# Work Order ID 94301

Item Name: Crosstube Fwd High

**D212-664-141/-141B  
ASSEMBLY DETAIL**

DRAWING NO. D212-664-141	TITLE XTUBE ASSY (205/212/412 HI FWD)	REV. D	DART AEROSPACE LTD ENGINEERING ORDER		D.E.O. NO. D212-664-141-D-1	SHEET NO. SHEET 1 OF 2	SCALE NTS
DRAWN	CHECKED	MFG. APPR.	APPROVED	DE APPR.			
DATE 11.04.07	DATE 11.07.11	DATE 11.04.12	DATE 11/04/12	DATE 11.04.12

**D212-664-141/-141B  
ASSEMBLY DETAIL**

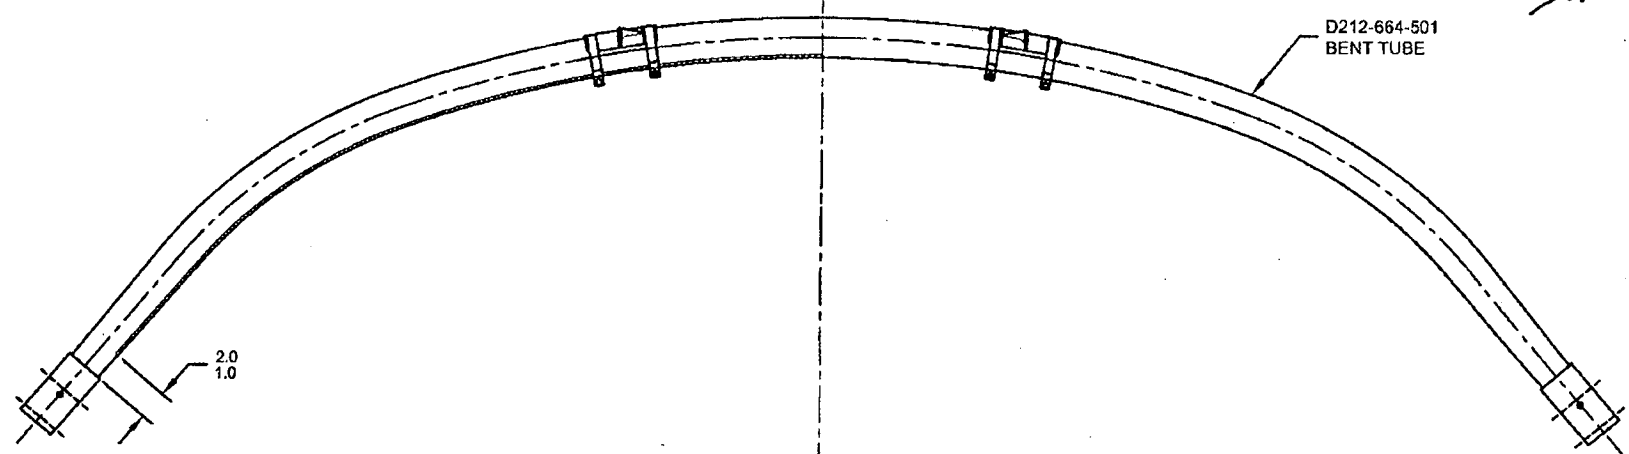
ADD AN INSPECTION WINDOW TO UNDERSIDE OF CROSSTUBE.

NOTES 2 OF SHEET 1 IS AMENDED AS FOLLOWS:

- 2) FINISH: CHEMICAL CONVERSION COAT PER DART QSI 005 4.1  
PRIME INSIDE AND OUTSIDE PER DART QSI 005 4.2  
MASK UNDERSIDE OF CROSSTUBE AS SHOWN (HATCHED AREA) AND  
PAINT OUTSIDE PER DART QSI 005 4.2  
REMOVE MASKING AND APPLY CLEAR COAT

MASK AREA PRIOR TO PAINTING,  
REMOVE MASKING AFTER PAINT  
AND APPLY CLEAR COAT
